Appeal NO: ABP 314485-22Defer Re O/H ☐Having considered the contents of the submission (dated) received 02/04/2024
fromSMTW Environmental DAC I recommend that section 131 of the Planning and Development Act, 2000
be (not) be invoked at this stage for the following reason(s): no new material issuesE.O.: Pat BDate: 19/04/2024

**RE: FURTHER INFORMATION PROVIDED TO AN BORD PLEANALA BY THE DAA
ON PLANNING APPLICATION F20A/0668**

Figure 1 Additional 7km² of Very Significantly Affected Area

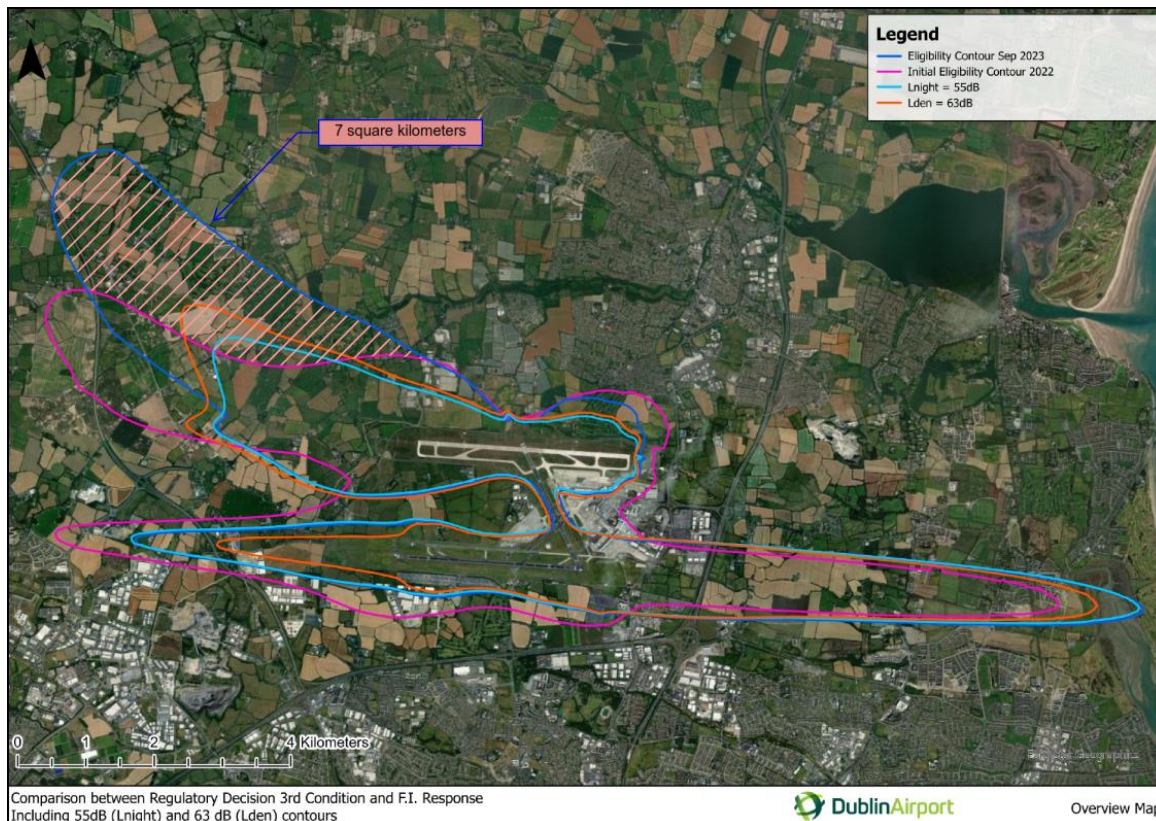
The information provided by the daa, in the form of revised eligibility maps, clearly illustrates the significant difference between the noise contours on which the ANCA regulatory decision and Fingal County Council planning decision were based. This confirms the central point of our appeal, the assessment has adopted different flight paths to those which were permitted as part of the North Runway EIS in 2007. The impact of changing flight paths is that areas find themselves significantly impacted by aircraft noise when they never expected to be impacted. In fact, over 7km² of newly affected areas are now so significantly affected they qualify for mitigation. Figure 1 illustrates the extent of this new area.

Figure 2 Daytime Noise Contours North Runway EIS 2007

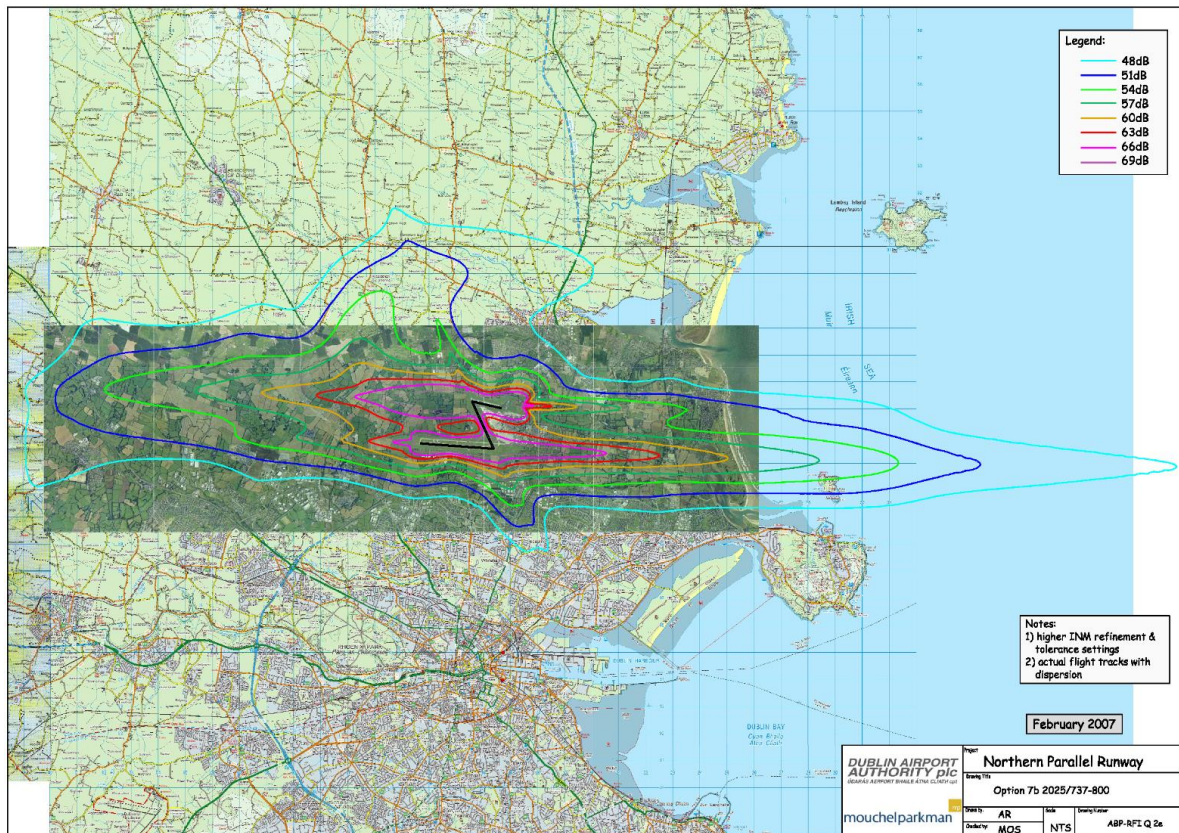
In the context of this appeal we contend that the significance of daytime impacts which result from the change in flight paths has not been adequately assessed.

Figure 2 illustrates the daytime noise contours produced for the year 2025 and submitted to An Bord Pleanála as part of a response to a request for additional information during the Oral Hearing into the North Runway in March 2007.

Figure 3 Daytime Noise Contours Relevant Action Supplemental EIAR 2023

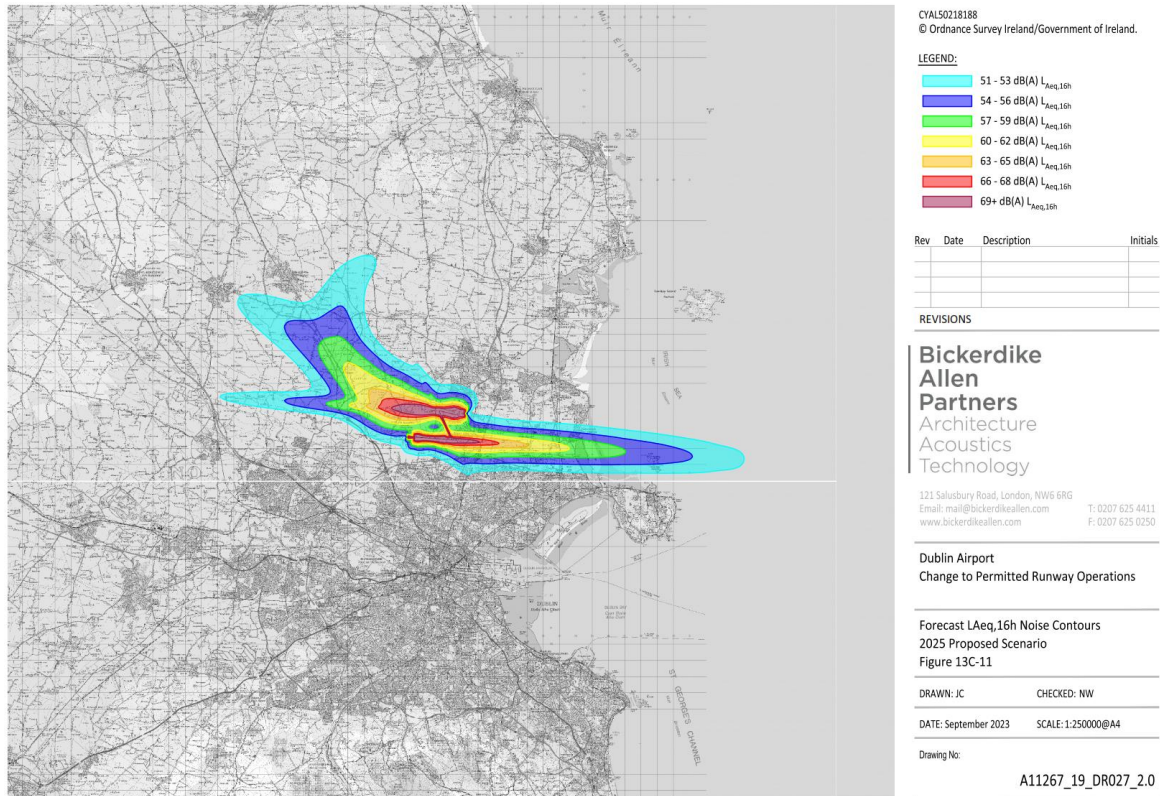
Figure 3 illustrates the same noise contours submitted as part of the supplemental EIAR DAA submitted in September 2023 as part of this appeal.

Figure 4 Comparison of 2024 57dB LAeq,16hr Noise Contour - 2007 EIS vs 2023 EIAR

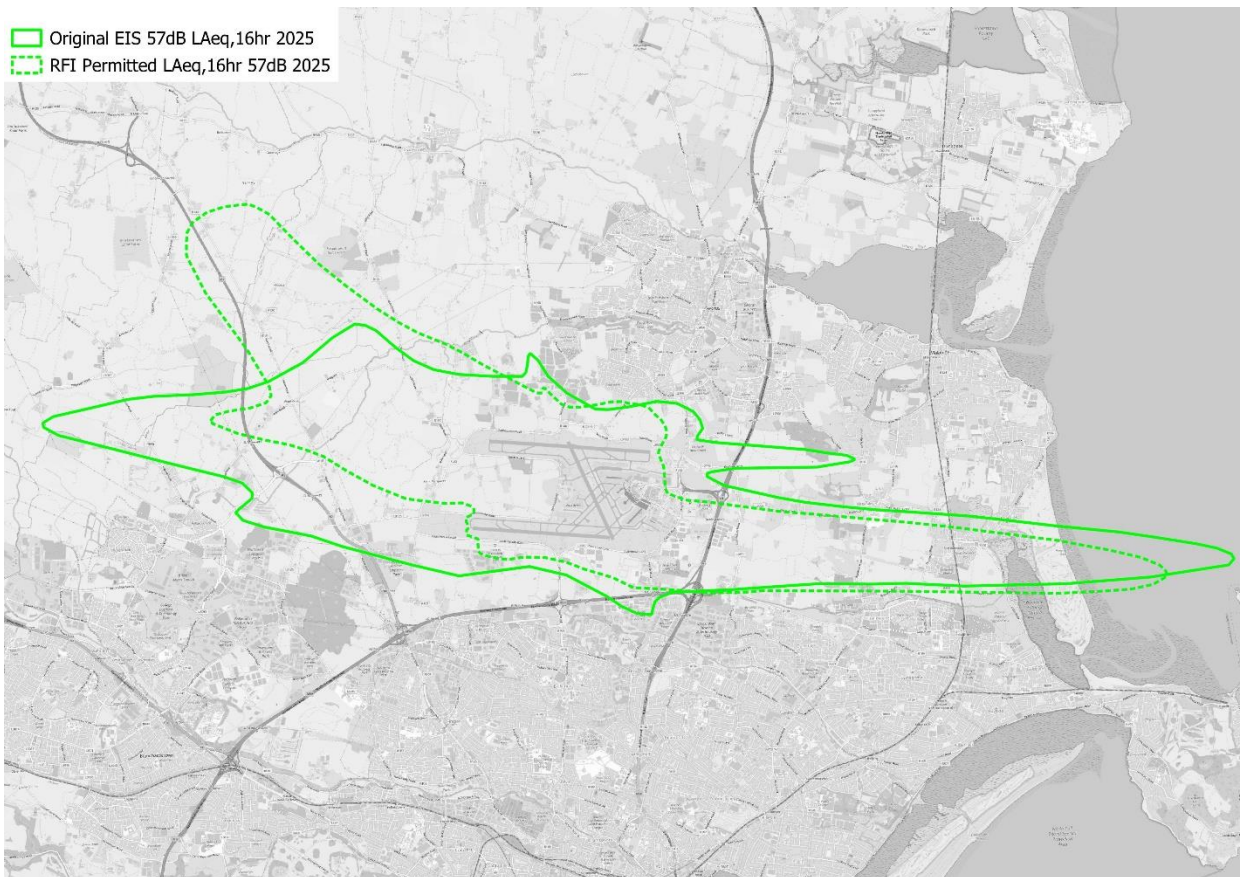
To help illustrate the large difference in the shape of the daytime noise contours Figures have been created by overlaying both sets of noise contours for the 57dB and 63dB $L_{Aeq,16hr}$ contours. The difference is obvious with many areas now exposed to higher daytime noise levels as a result of different flight paths. The significance of the daytime noise impact has not been assessed.

It is clear that there are areas now experiencing very high relative changes in the daytime noise level expected based on the original North Runway EIS versus the proposed development. This very high impact rating is not assessed for significance with is a fundamental flaw in the assessment.

Figure 6 Comparison of Monitoring Locations to DAA Summer 2023 Noise Contours

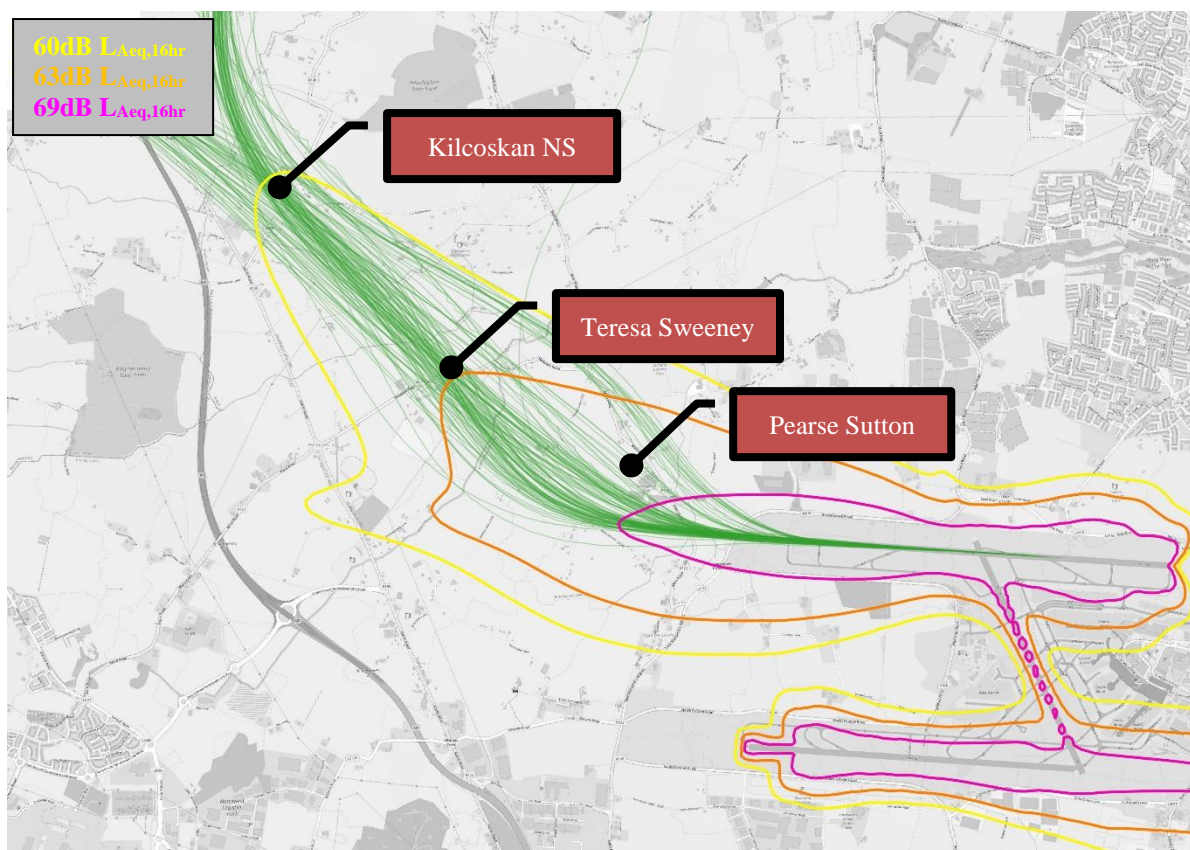
Figure 6 presents the locations of the noise monitors with westerly departure flight paths also indicated in green. Overlaid on the image are the noise contours for the Summer 2023 period produced by daa and included in the Infrastructure Application (Reg Ref. F23A/0781).

Figure 9 Single Mode 55dB L_{night} Contour

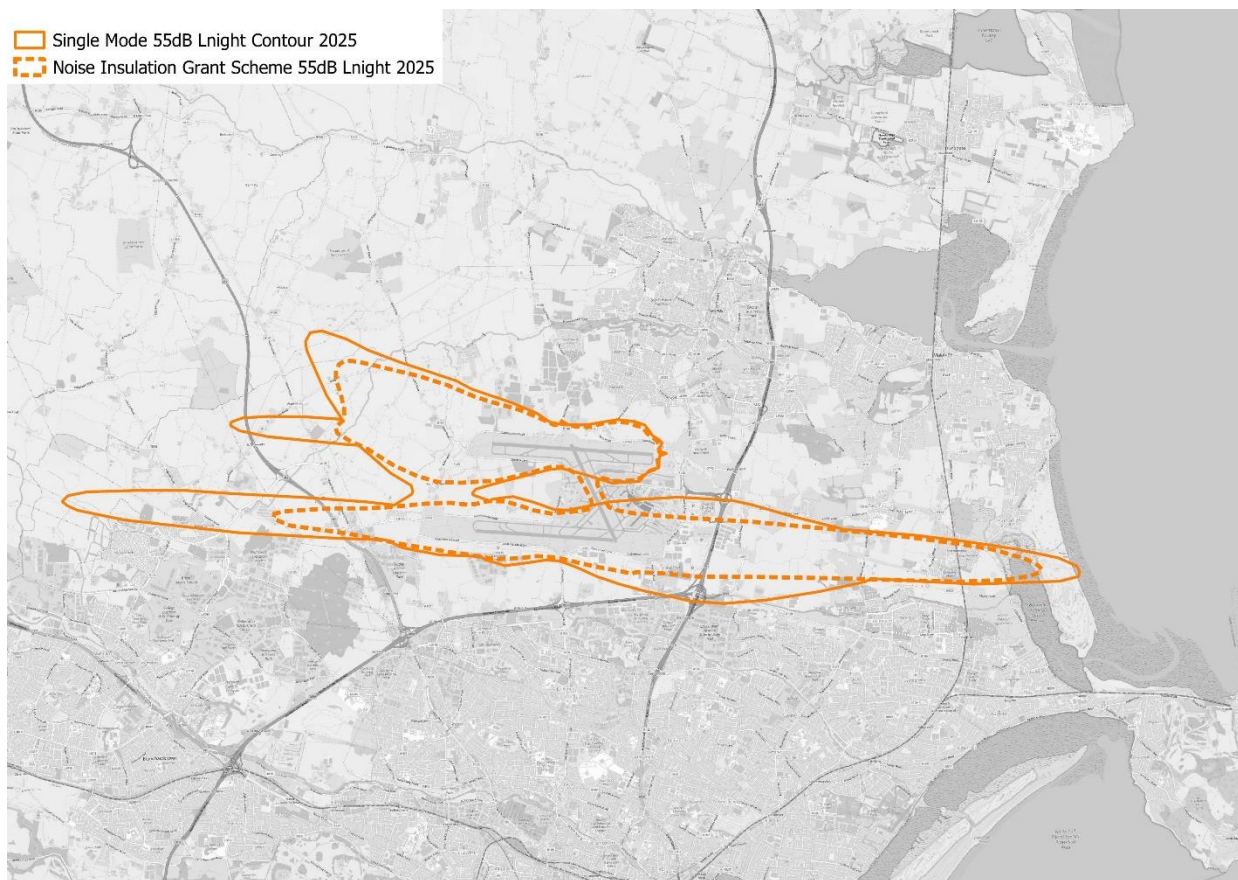
It is possible to combine the 55dB L_{night} contour from both easterly and westerly scenarios to determine a worst-case single mode 55dB L_{night} contour. Figure 9 presents a comparison of the 55dB L_{night} contour proposed by DAA as a qualifying metric for the noise insulation grant scheme with the single mode 55dB L_{night} contour.

Reviewing the areas it is clear that many more dwellings can be exposed to 55dB at night than the current eligibility contour for RGIS would determine. A similar exercise should be done for the second eligibility criteria of areas that experience 50dB L_{night} and an increase of 9dB or more above the expected noise level.

The result of our analysis shows that DAA dilute significantly the areas that may experience significant noise levels by adopting an approach that uses a modal split. We submit that it is necessary for the planning authority to redefine the definition of all noise contours used for mitigation measures to ensure that single mode contours are produced. This would align with the approach FCC used for the Noise Zones around Dublin Airport and ensure that all affected areas are mitigated for noise exposure they may receive on any given day.

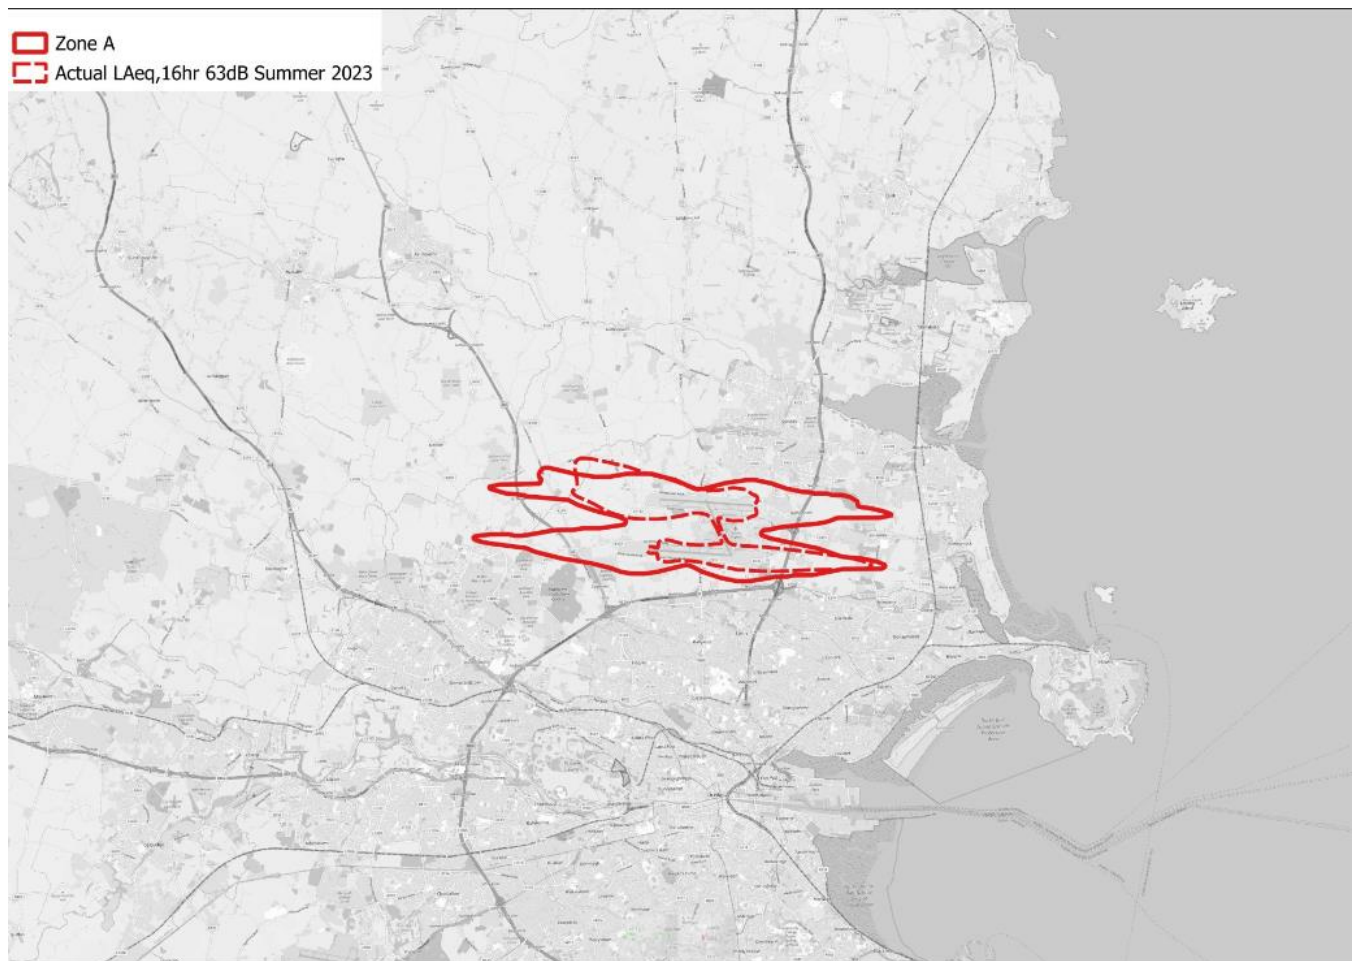
The image below is a comparison of the 2023 63dB LAeq16 Summer contour with Noise Zone A. The 2023 63dB LAeq16 noise data and contours were submitted by the daa as part of their Infrastructure Application (F23A/0781). It is clearly evident that the operations in 2023 violated Noise Zone A. Again, it is worth highlighting that the Noise Zones are based on 100% Single Mode operations for both departures and arrivals from all four runways (10L, 10R, 28L and 28R). This was done to capture the worst-case noise scenario on any given day.

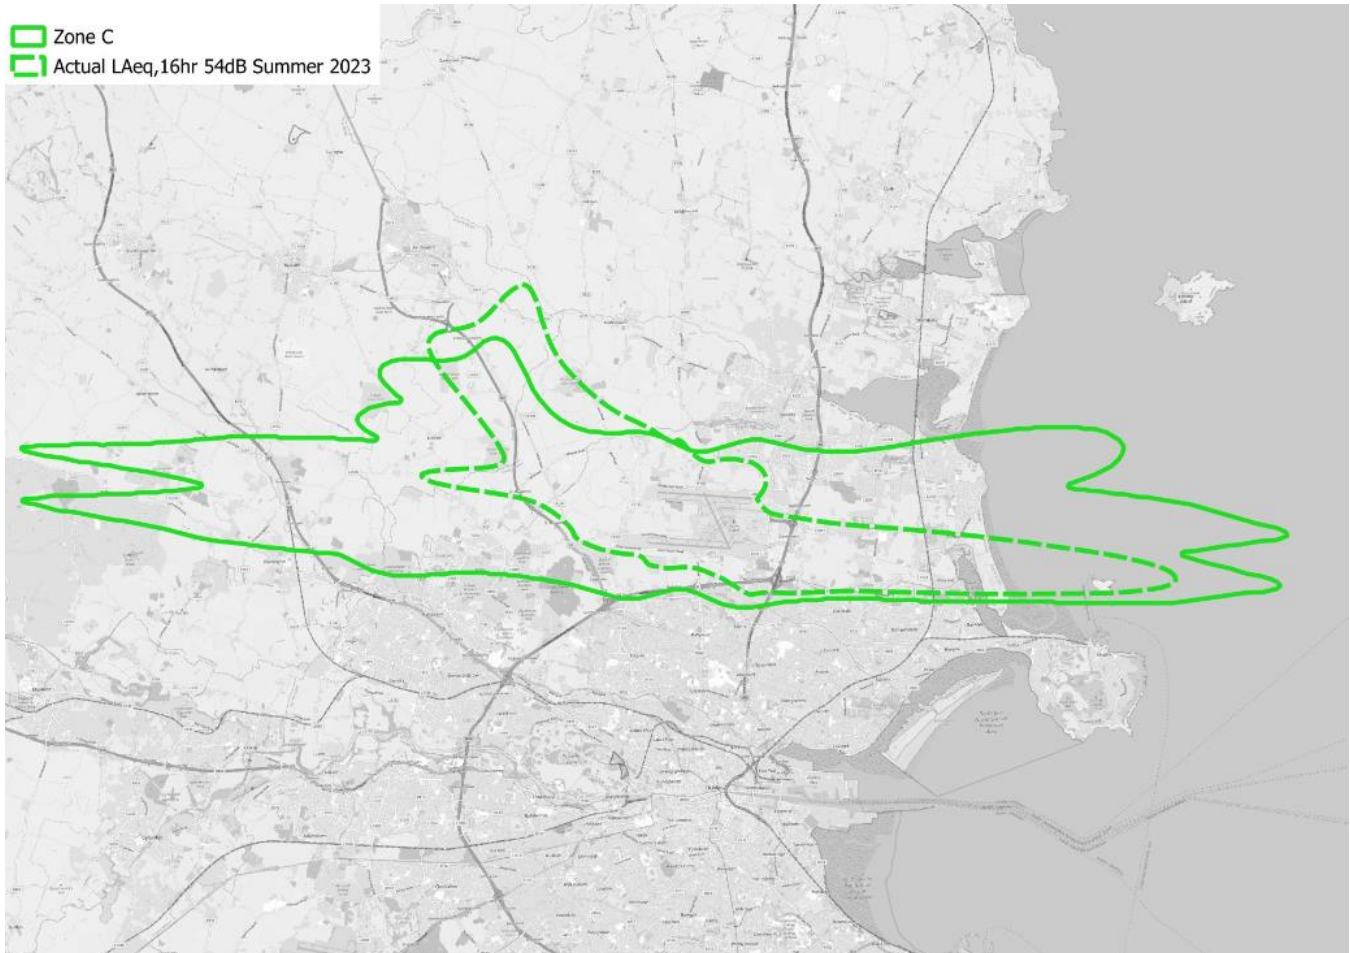
The image below is a comparison of the 2023 54dB LAeq16 Summer contour with Noise Zone C. It is clear that the 2023 operations are in material contravention of both the Meath and Fingal Development Plans.

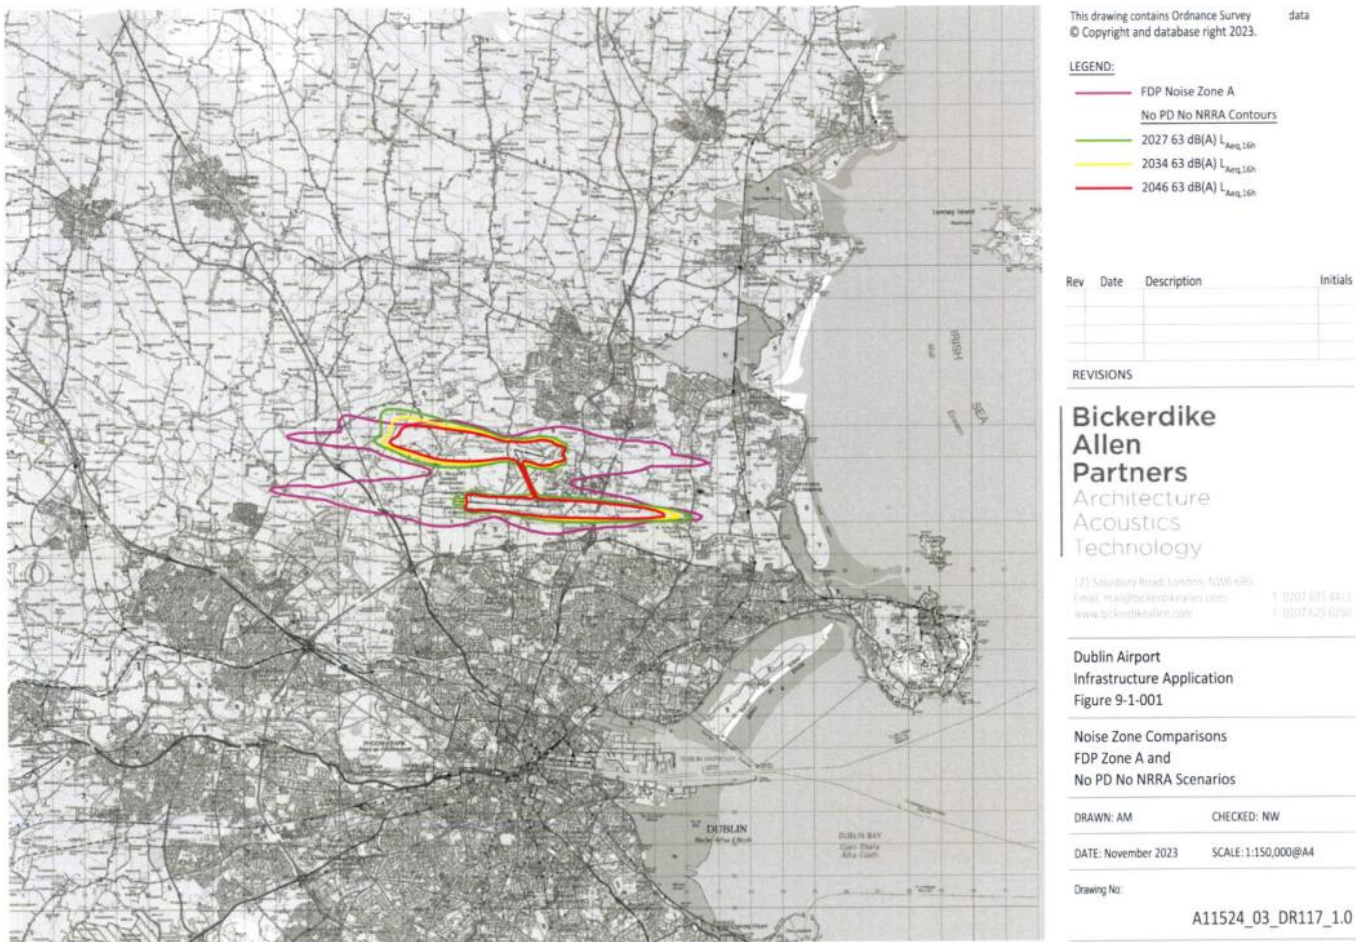
Section 9-1.8 is titled ‘Comparison with Dublin Airport Noise Zones’. Figure 9-1-001 shows that the 2027 63 dB LAeq16h contour for ‘No Proposed Development (PD)’ and ‘No North Runway Relevant Action (NRRRA)’ lies outside Zone A of the Development Plan. The 2027 No PD No NRRRA scenario is equivalent to the 2025 Permitted scenario in the Relevant Action as it has the 32m passenger cap in place and no Relevant Action. Even without the Relevant Action the current flight operations do not comply with Noise Zone A:
